## El Paso County Park Advisory Board

### Agenda Item Summary Form

**Agenda Item Title:** Lorson Ranch Sketch Plan Amendment No. 2

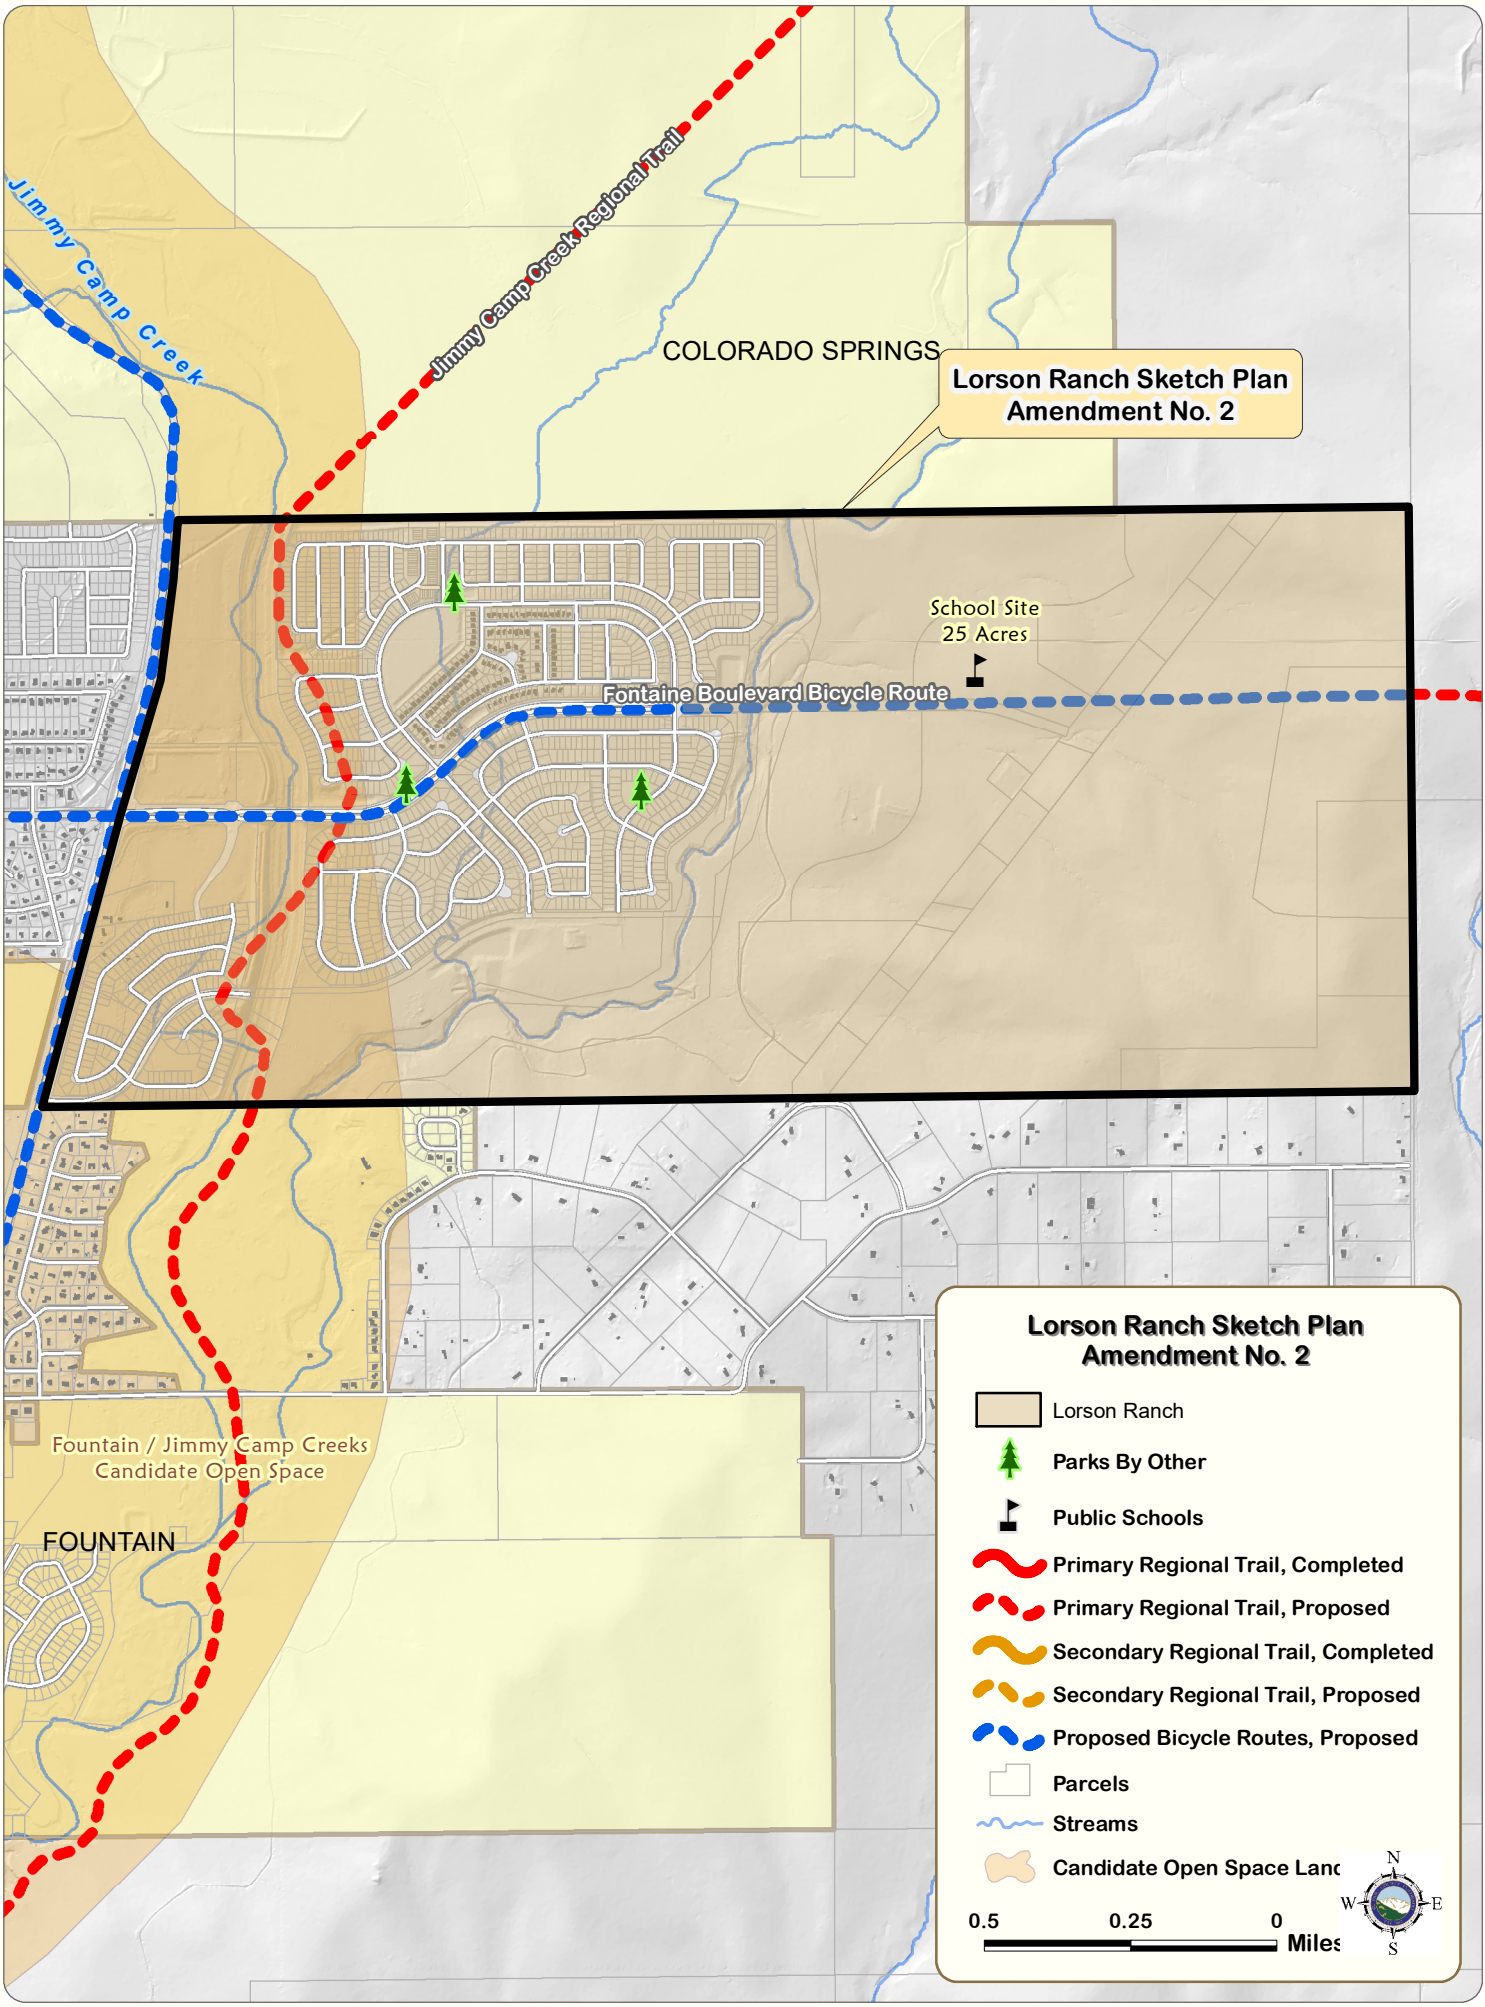
The sketch plan includes open space dedications totaling 212 acres, or 15.0% of the site. This is in accordance with the previously approved sketch plan and includes the Jimmy Camp Creek, the East Tributary, the power line easement, future school site, and various tracts throughout the development. Staff notes several changes to the open space configuration along the East Tributary but it is in general agreement with the previously approved sketch plan.

The applicant also included in the letter of intent, language outlining that additional open space areas will be created during detailed subdivision planning in the form of park, trail, and open space tracts. These future open space acreages will be in addition to the 212 acres previously included within the approved sketch plan, and will be identified in forthcoming PUD's and preliminary plans. Staff appreciates the applicant is providing additional open space, park, and trail opportunities; however the sketch plan drawings lack any specificity with identifying future park, trail, or open space tracts east of the East Tributary.

Consistent with the LDC, land uses, including open space, trail and park locations, should be conceptually identified on the sketch plan. Lots shall have reasonable access to open space, trails, park land or recreational facilities that are set aside for either homeowner use or use by the general public. Staff strongly recommends that the developer include conceptual trail locations and identify future park and open space areas east of the East Tributary, including approximate acreages for each location. All future park locations should be labeled and sized according to their type (e.g. neighborhood, community).
